RENOVATION AT 833 BARONNE  
833 BARONNE ST. NEW ORLEANS, LA 70130

DRAWING TITLE:  
EXTERIOR ELEVATIONS

DRAWING TITLE:  
DETAIL DRAWINGS

01 O'KEEFE AVE (SIDE) ELEVATION  
A201 3/16\"/>

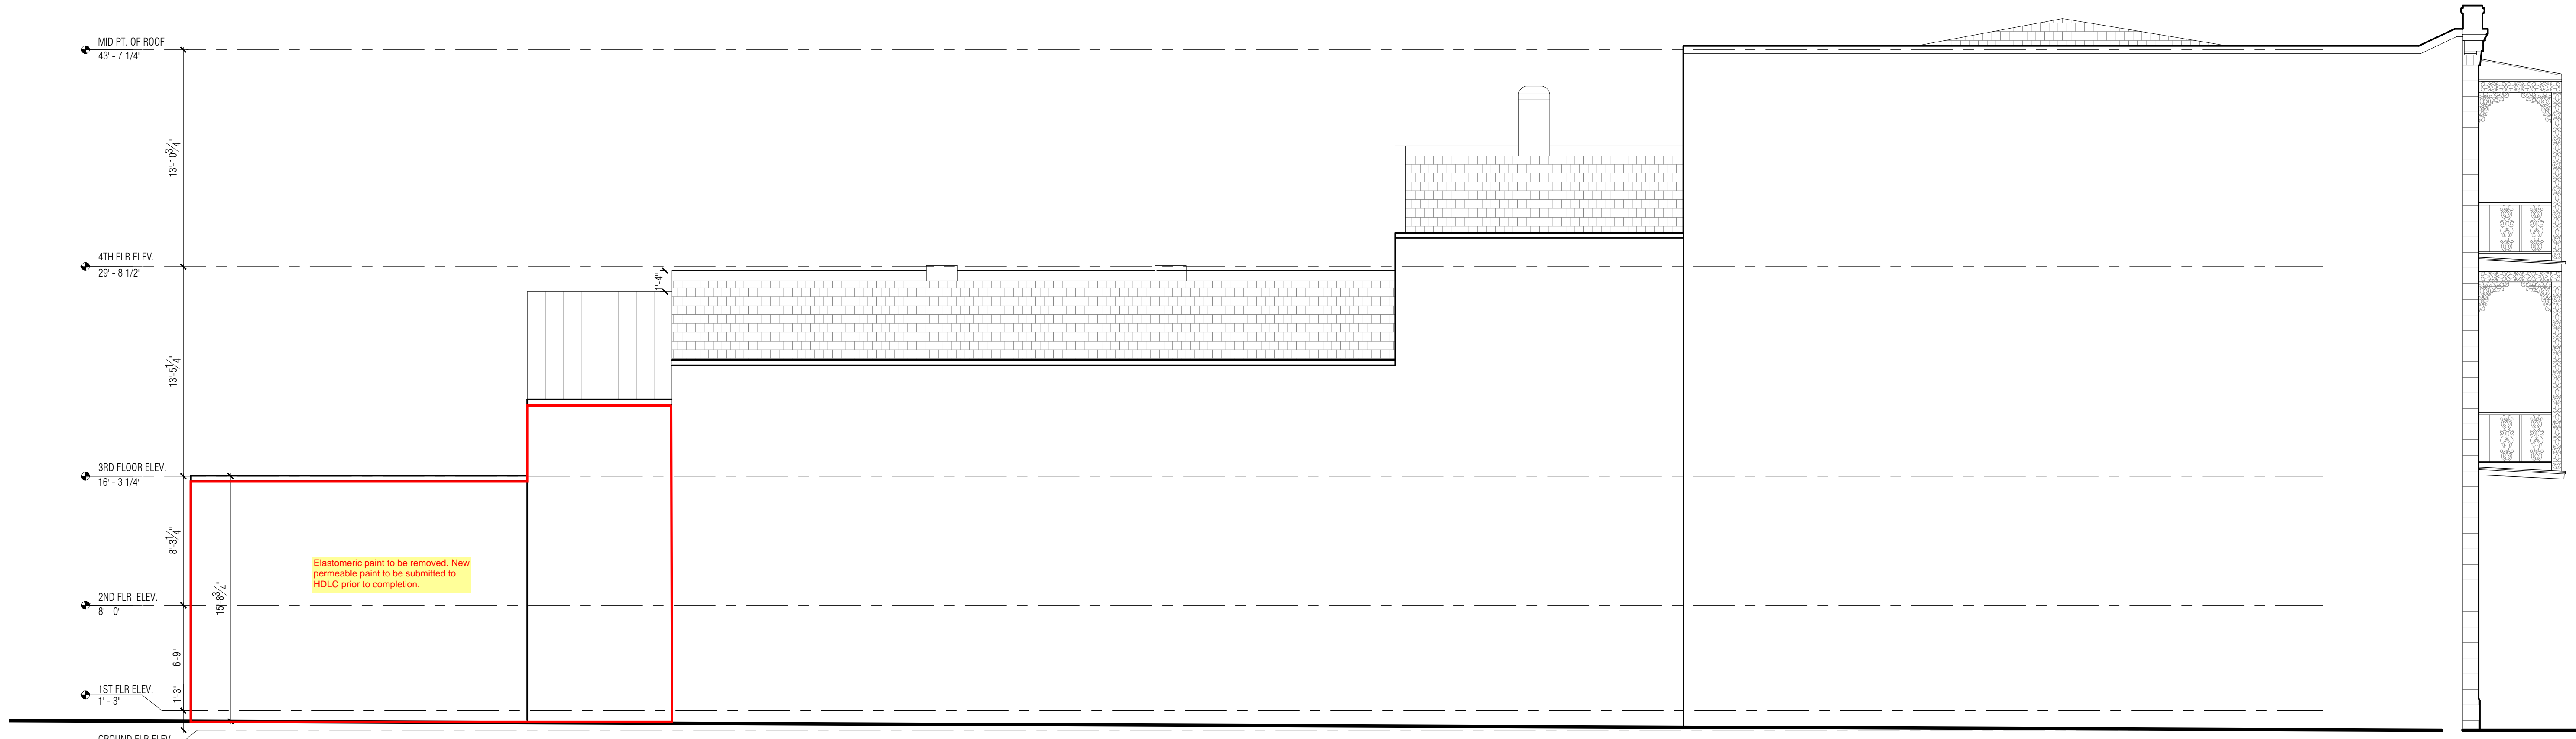
FILL IN EXISTING OPENING @ EXISTING ELEVATOR SHAFT WITH BRICK TO MATCH ADJACENT CONDITIONS. RECESS BRICK 2\"/>

ELASTOMERIC PAINT TO BE REMOVED. NEW PERMEABLE PAINT TO BE SUBMITTED TO HDLC PRIOR TO COMPLETION.

EXISTING BALCONY TO REMAIN. BRACE AS REQ. TO ACHIEVE RESISTANCE FOR 50 LBS / LINEAR FOOT. Details of bracing to be submitted.

REPLACE EXISTING BALCONY DECKING TO MATCH ORIGINAL CONDITIONS. PAINT TO BE SELECTED BY OWNER/ARCHITECT.

Need section details of trim

ELASTOMERIC PAINT TO BE REMOVED. NEW PERMEABLE PAINT TO BE SUBMITTED TO HDLC PRIOR TO COMPLETION.
